## Detailed Plan Development

For the development known as Block 6- Arena Master Plan, Phase 1 for the development of a hotel on the southern portion of 420 West Juneau Avenue.

March 18, 2021

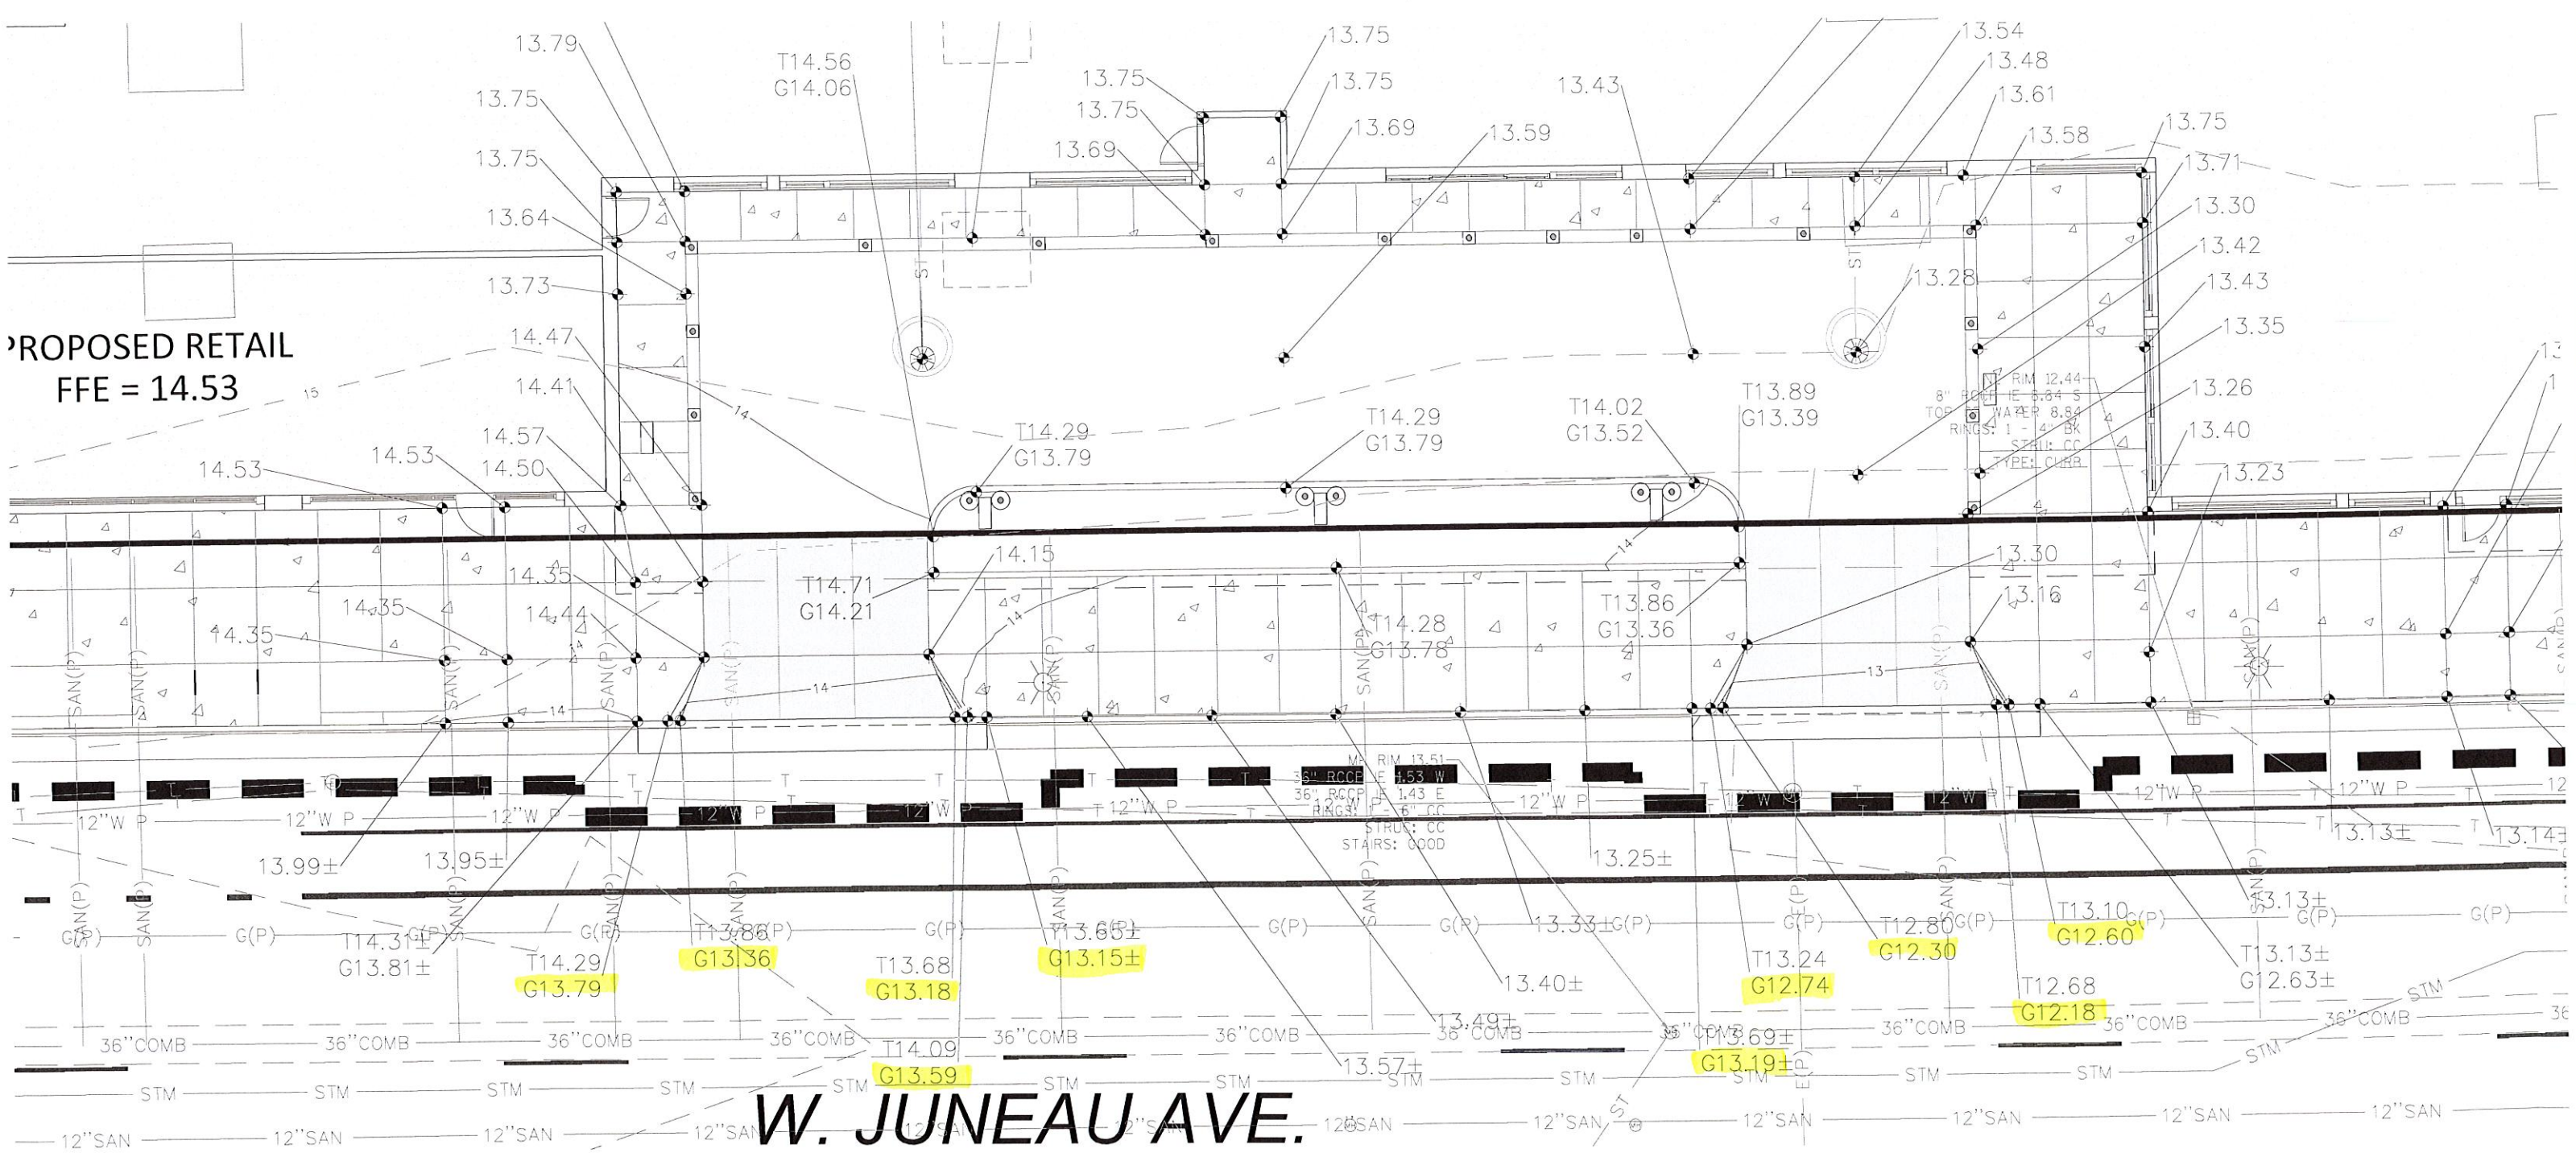
The gutter grades shown on the plans adjacent to the drop-off area on West Juneau Avenue may not be shown correctly. Please see the attached highlighted plan.

The plans indicate that the entrance to the bar/lounge area in the southeast corner of the first floor will be served by a non-accessible entrance. This entrance is located in a very prominent location at the northwest corner of Vel R. Phillips Avenue and West Juneau Avenue, directly across the street from the Fiserv Forum. The closest accessible entrance is one-half block to the west and would force patrons of the bar/lounge area to venture through the hotel lobby only to head back to the east approximately one-half block. Given the prominence of the bar/lounge portion of the facility within the Deer District, Planning & Development requests that efforts be made to make this building entrance accessible.

The plans indicate that there is a 7-inch elevation difference between the floor of the building and the adjacent sidewalk. The Department of Public Works (DPW) can provide technical assistance regarding design of modifications to the intersection corner, including, but not limited to, the existing pedestrian ramps, curb and gutter, and sidewalk.
